H12260

## DESCRIPTIVE REPORT

*General Locality* Krenitzin Islands

## Revisions and Corrections performed during office processing and certification.

## 1.5) Profile/Beam - 1012/476 from sheet\_a04 / 3-d2 / 2010-186 / 3a04-sh232

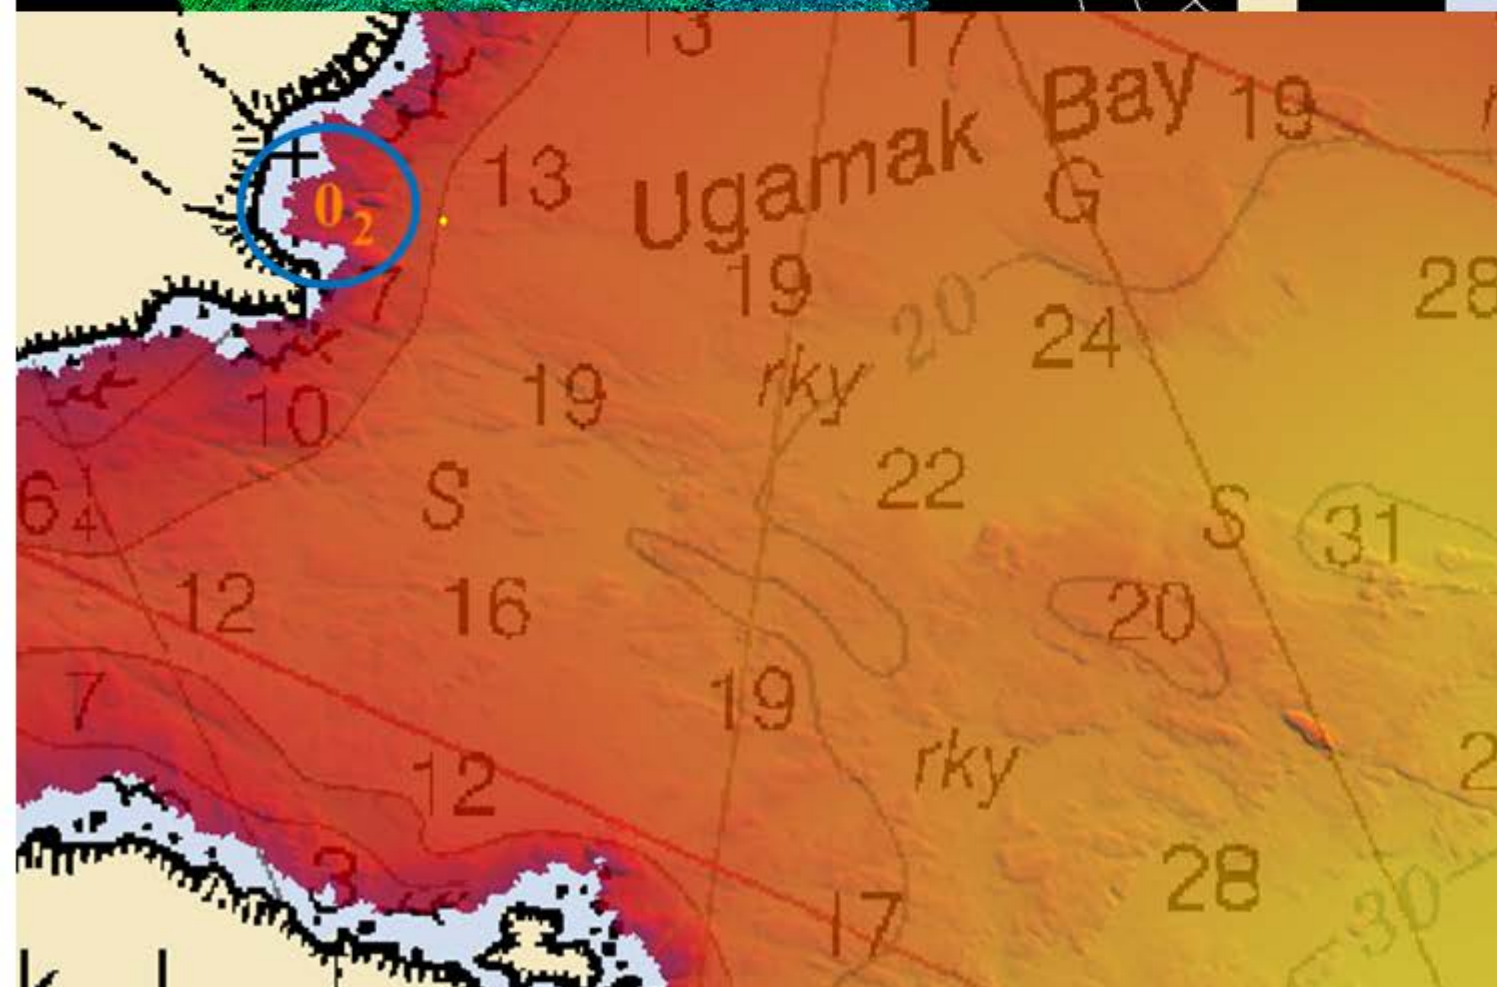
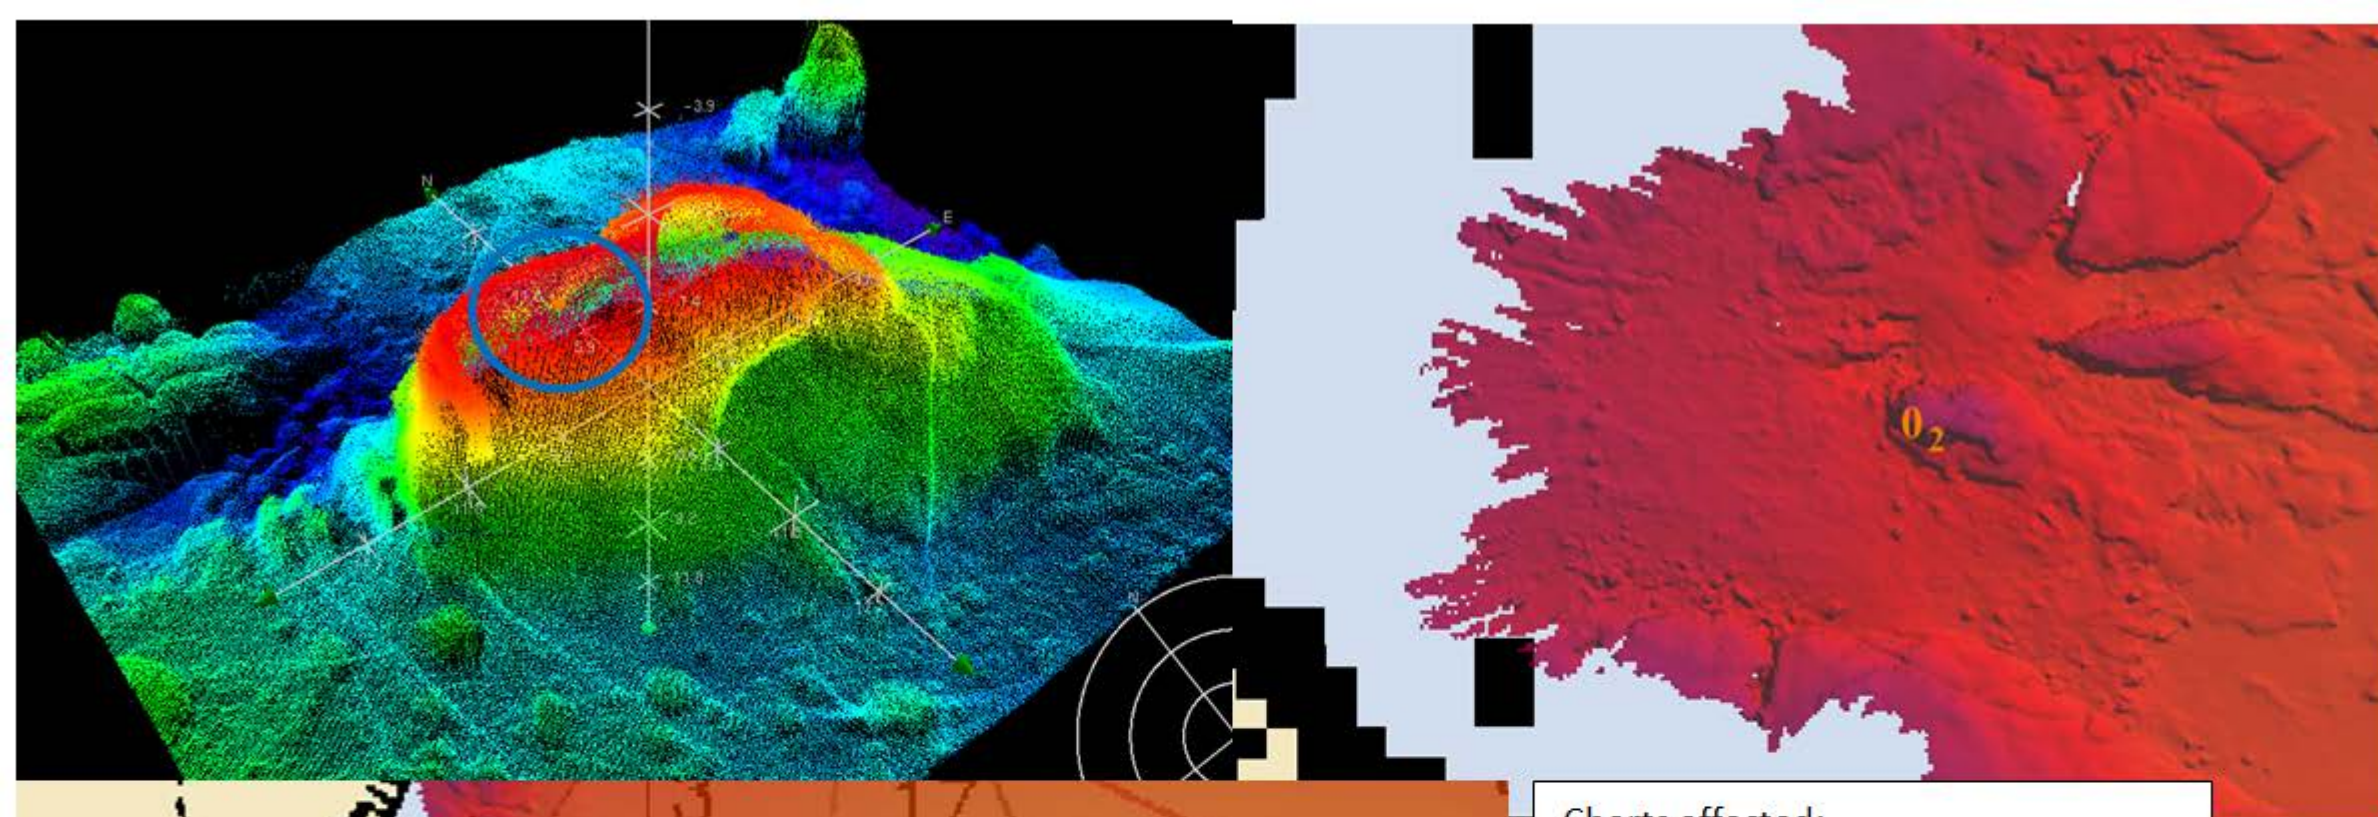
Chart as DTON

DTON #1.5 was not applied to the chart by MCD;

It was compiled to the chart update product as a 0 fm 2 ft submerged rock.

**1.6) Profile/Beam - 31913/473 from sheet\_a01 / 3-d2 / 2010-182 / 3a01-sh176****DANGER TO NAVIGATION****Survey Summary**

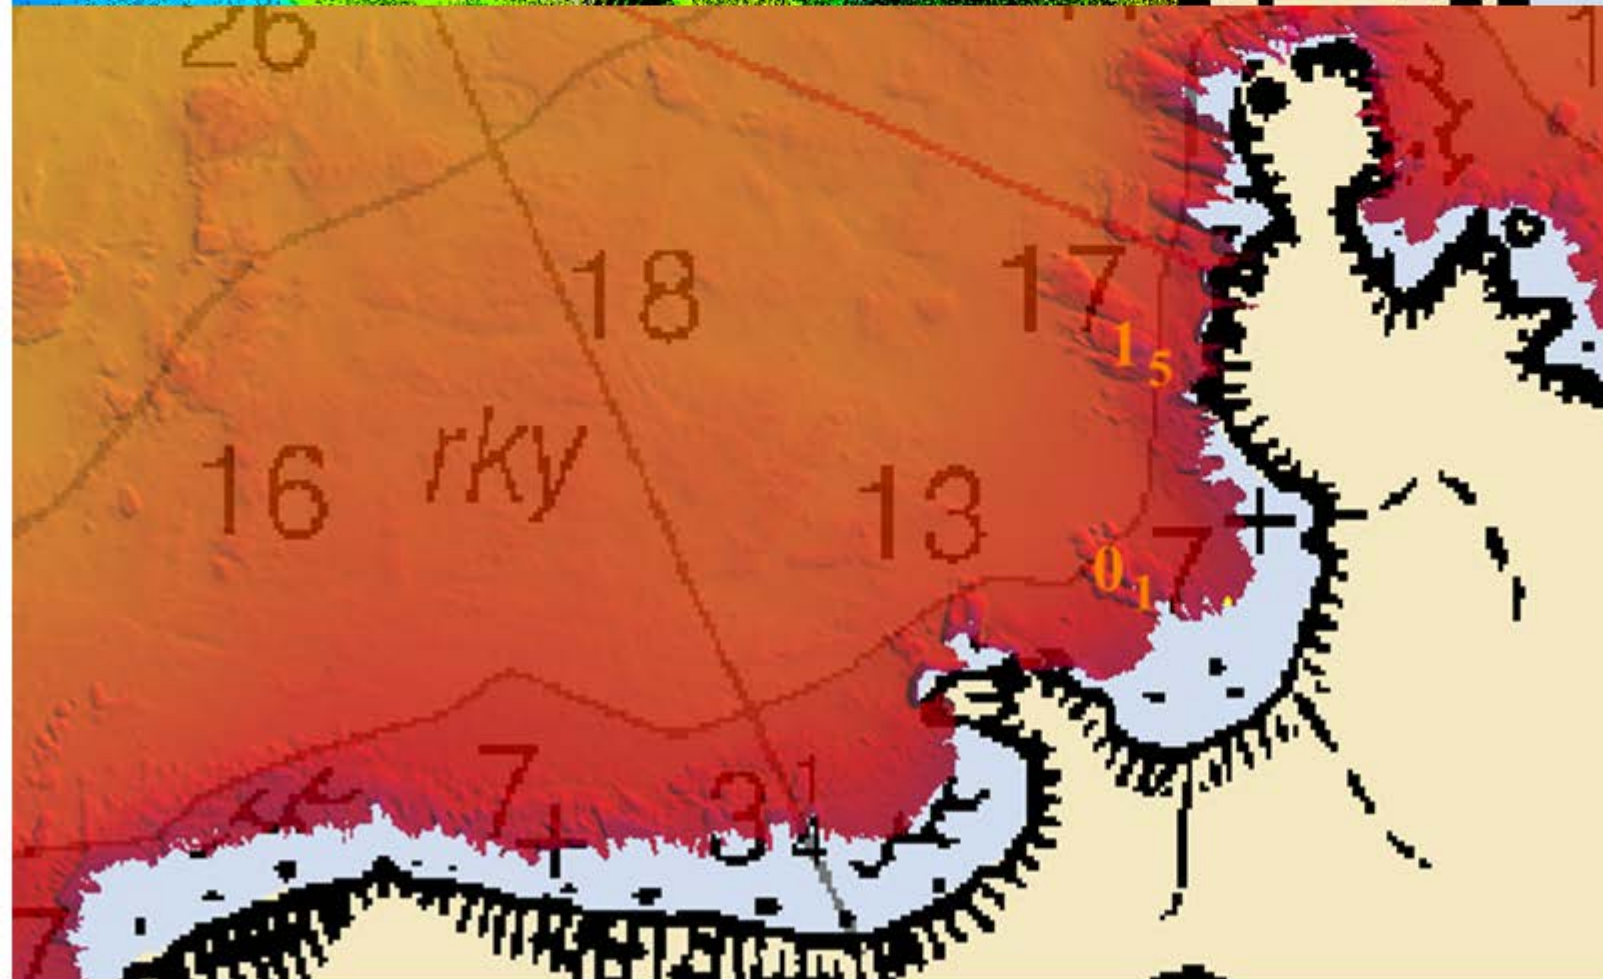
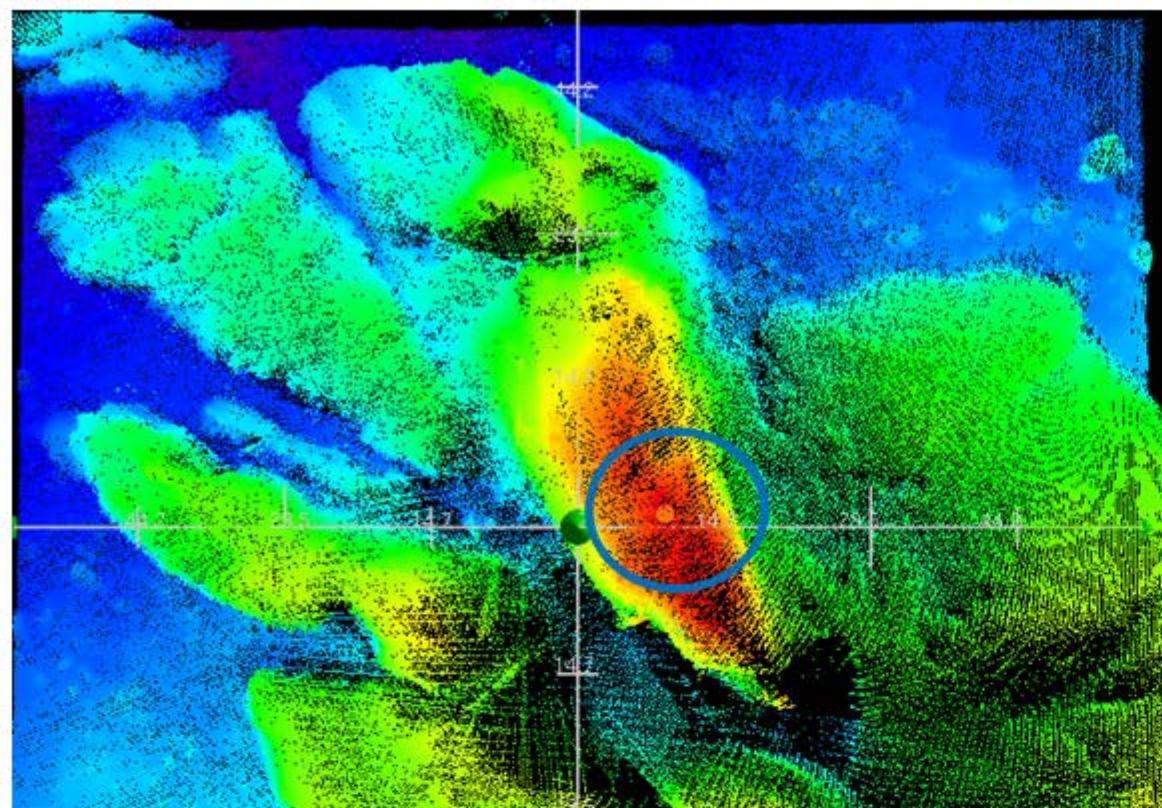
chart as DTON

DTON #1.6 was applied to the chart by MCD as a rock awash;

It was compiled to the chart update product as a 0 fm 1 ft rock awash.
